# WAITSFIELD DEVELOPMENT REVIEW BOARD MEETING AGENDA

STAFF REPORT by J.B. Weir for January 14, 2025 meeting

Application #: SUB 24-02 Landowner: Mavis, LLC

Proposed PUD- "Glideslope Villas". 14-Unit Clustered Housing Development. Off Mad River Park Rd. Ag-Res District. Preliminary Review. Applicant/Landowner: Mavis, LLC.

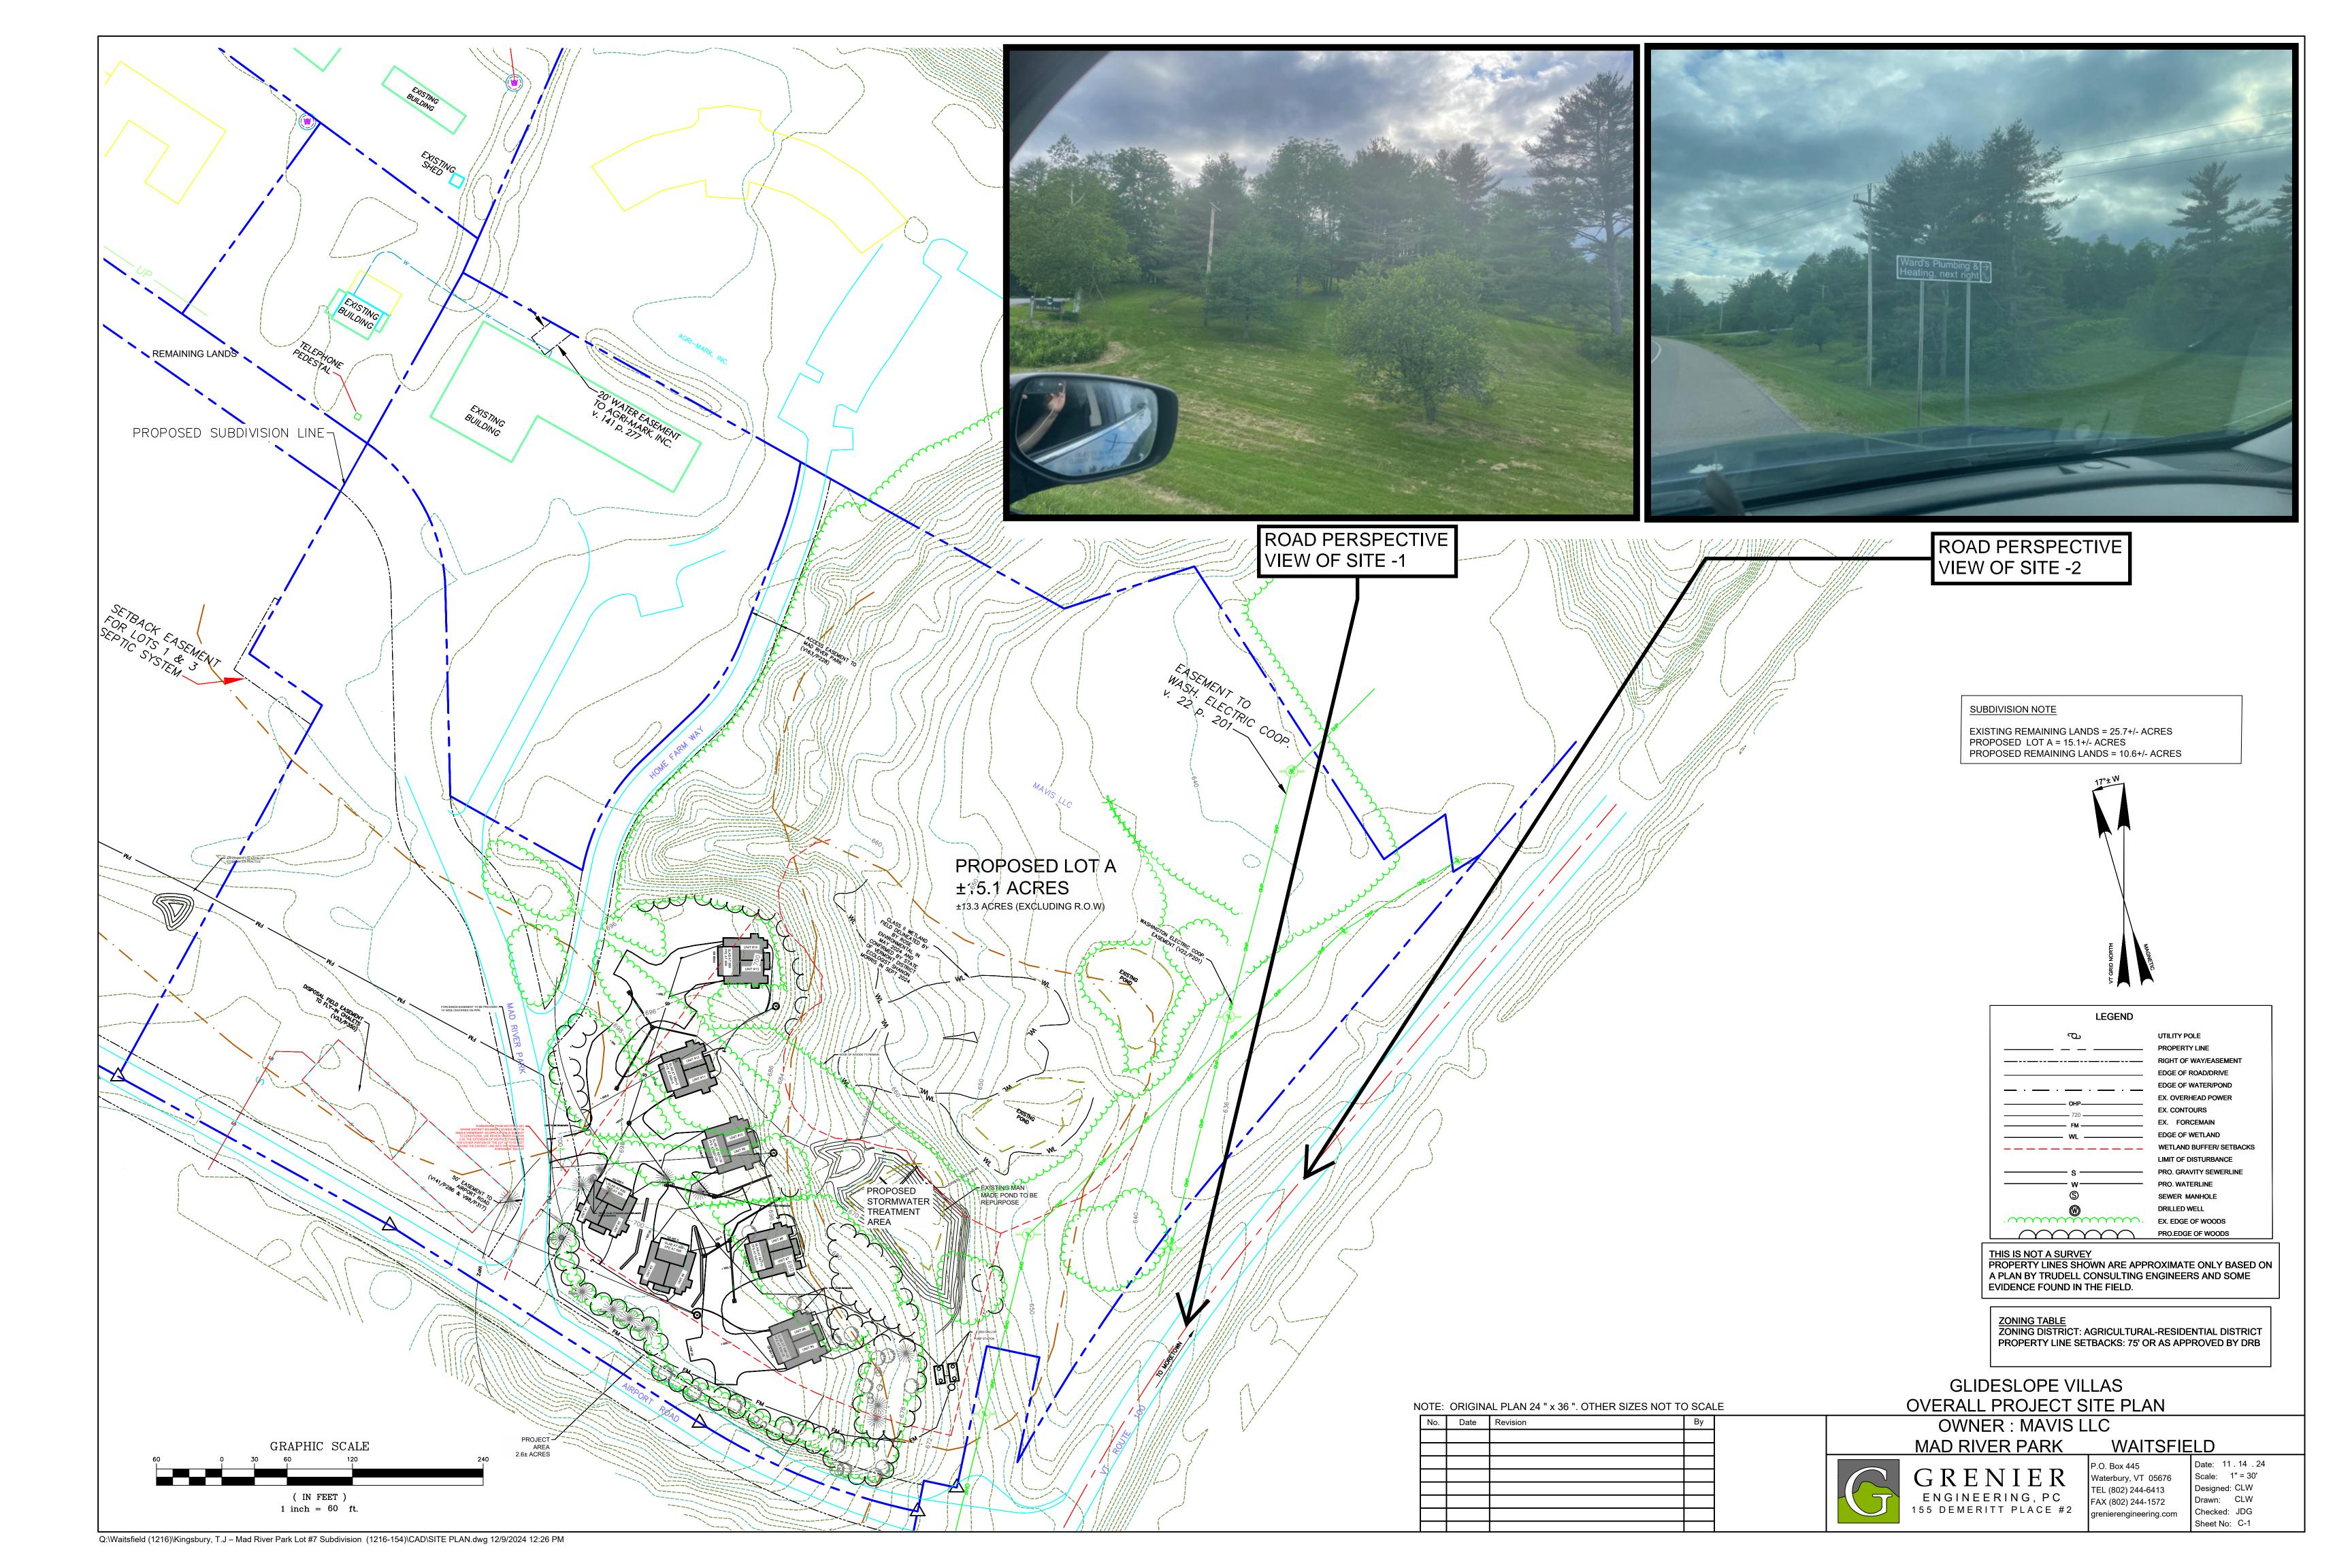
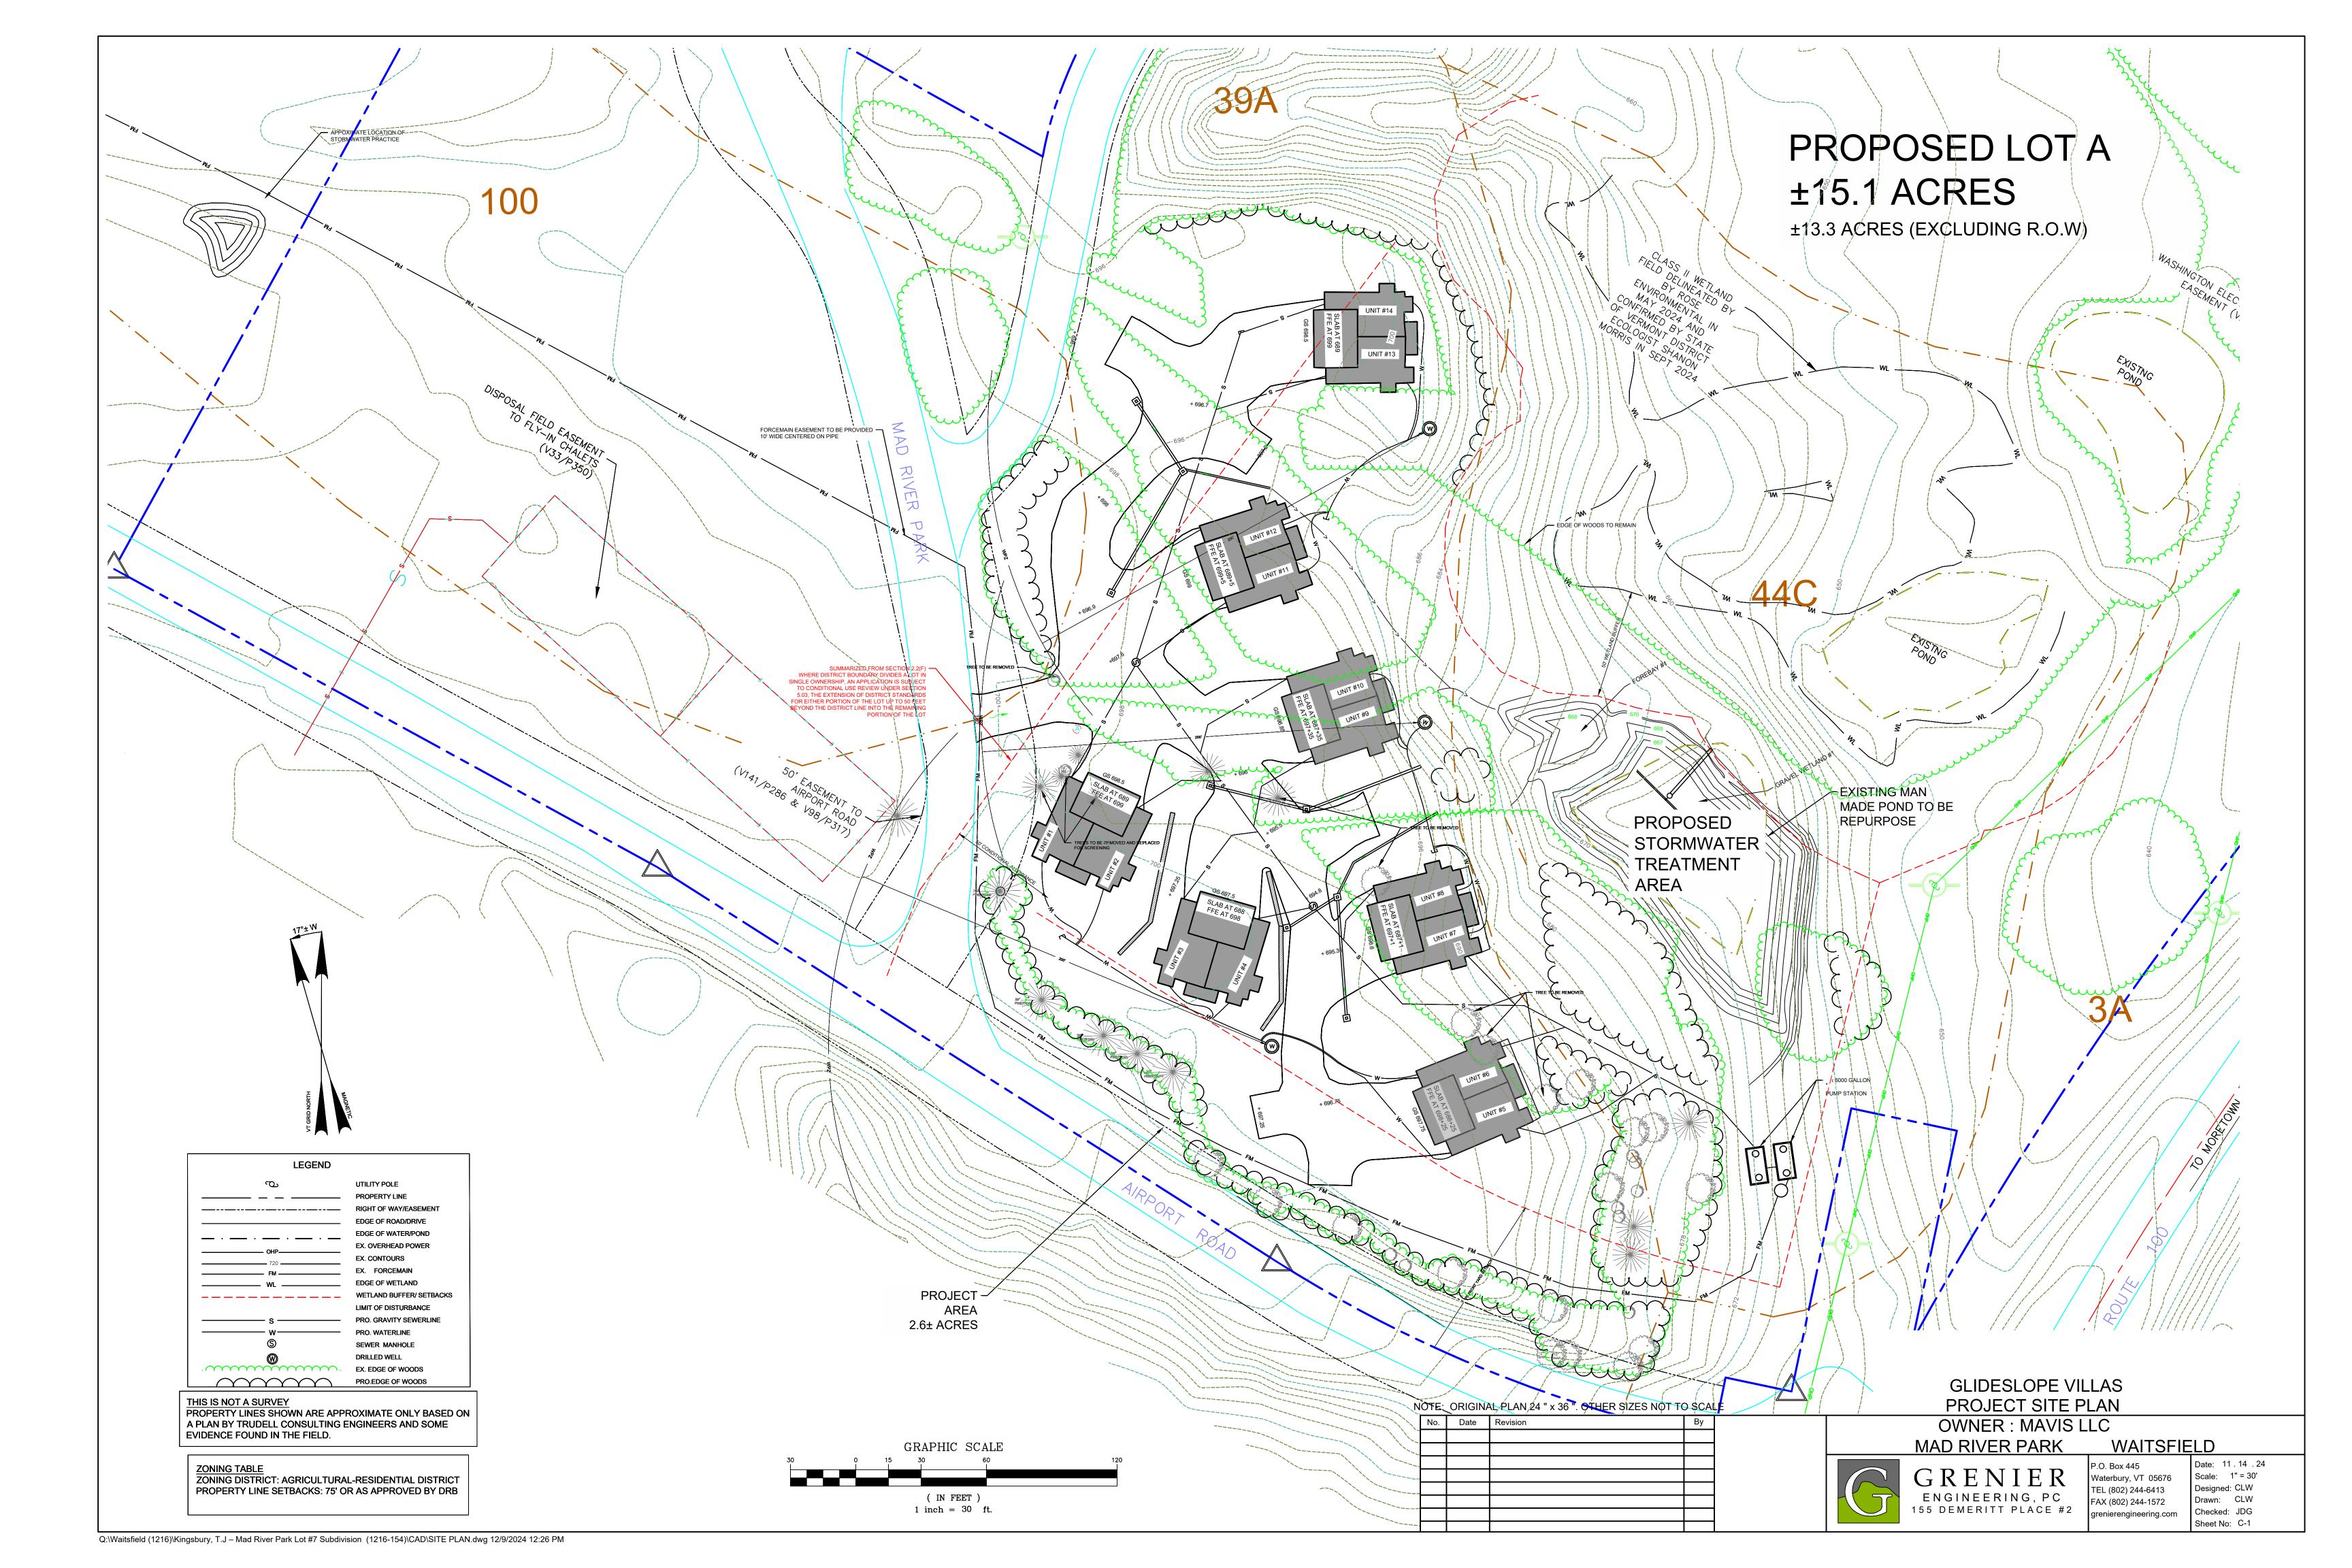
- Route 100 will be mostly maintained, but that there will be some tree removal. Applicant's updated plans reflect the specific trees to be removed and those to be retained to provide adequate screening from Route 100. (See Project Site Plan, Sheet C-1 depicting existing vegetation and proposed vegetation.)

- 22. Sketch Plan review was held on June 11<sup>th</sup>, 2024.
- 23. Per the Board's determination on Sketch Plan Review, the applicant was to submit screening and tree-cutting plans for Preliminary Plan review. As discussed above, applicant has updated the site plans to include further detail on specific trees to be removed and those to be retained for project screening.

- 24. Per the Board's determination on Sketch Plan Review, the applicant was to adjust the location of the proposed duplex-unit 8 such that the unit is predominantly situated within the extended 50-foot district boundary. Subsequent to Sketch Plan Review, applicant revised the proposed building layout to include only 7 duplex buildings all of which are

- a./b.- The site plans now contain further detail on specific trees to be removed and to be retained for project screening.
- c.- The proposed building layout has been revised. The project now only includes 7 duplex buildings and they are all situated within the Ag-Res. District and/or the extended 50' district boundary.
- d. The Waitsfield Fire Chief has provided his review and approval of the proposed PUD site plan, which is enclosed.
